Title: Advisory Committee on Reactor Safeguards
ABWR Subcommittee on STP COLA

Date: Tuesday, February 8, 2011

Chapter 7

Instrumentation and Control Systems

COLA Figure 7C-1 Implementation of Additional Diversity in SSLC to Mitigate Effects of CMF

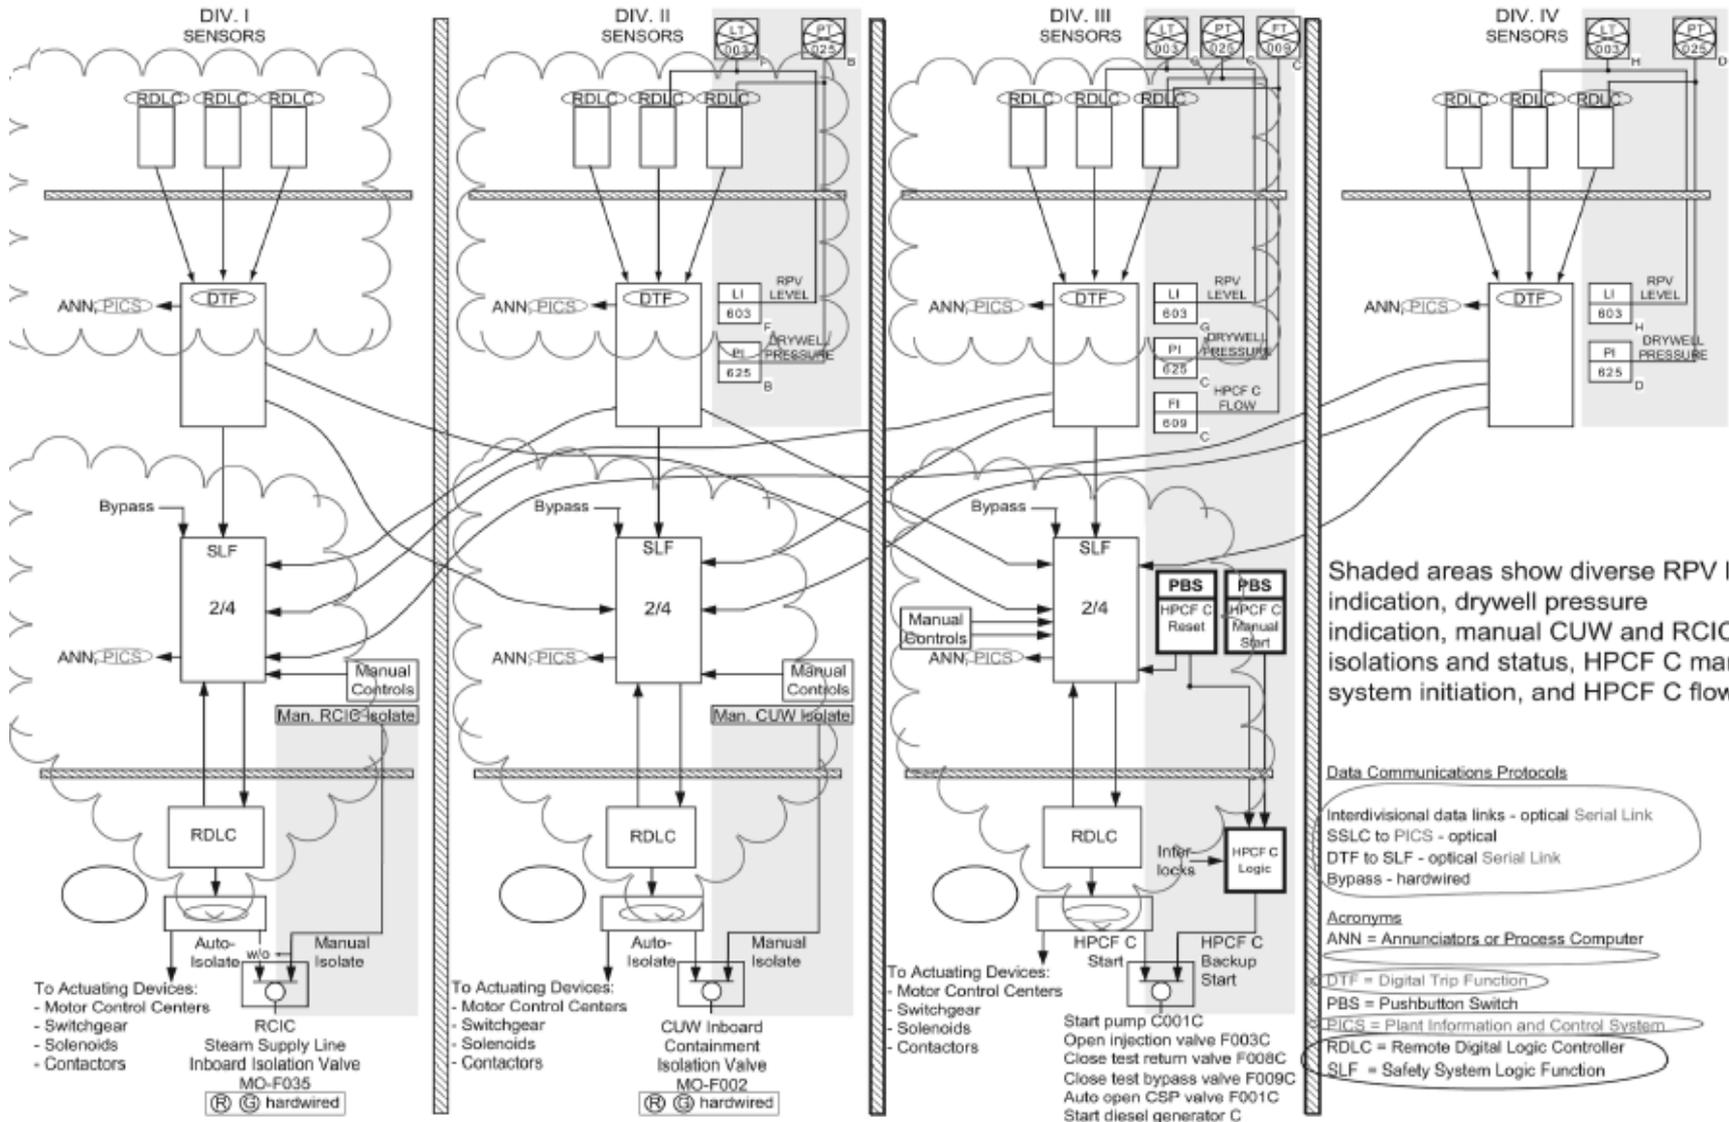
22 MEMBER BROWN: So there's a nuance. If I
23 look at Figure 7C-1, where that -- in other words,
24 there's a set of manual controls that go into the
25 SLFs, and then there's another set of manual controls

9 MEMBER STETKAR: Only that's not what this
10 drawing says.

3 CHAIRMAN ABDEL-KHALIK: Thank you. Before
4 we take a break, I think we ought to capture the
5 briefings that you need to clarify. Number one,
6 you're going to go back and look at Figure 7C-1, 7C-1
7 to try to answer John's question; is that correct?

2 MR. MURRAY: I'd like to see the figure.
3 Let me make sure I understand it. That is correct, in
4 that the SLFs -- in other words, operator ability to
5 control the component from the control room, he has
6 the ability to start and stop it with logic that's
7 carried out through the ESF -- ELCS system basically.

5 The logic will change to the other logic
6 channel, one out of one. So that the system level
7 controls will still operate. The manual control, an
8 individual component with a flat screen display, soft
9 control, that does not go through the SLF. The SLF is
10 for system level functions.

4 MR. HEAD: We understand, okay. Thank
5 you. So the first one I propose is to go back to
6 Figure 7C-1, which we have on the board, excuse me,
7 on the board, sorry.
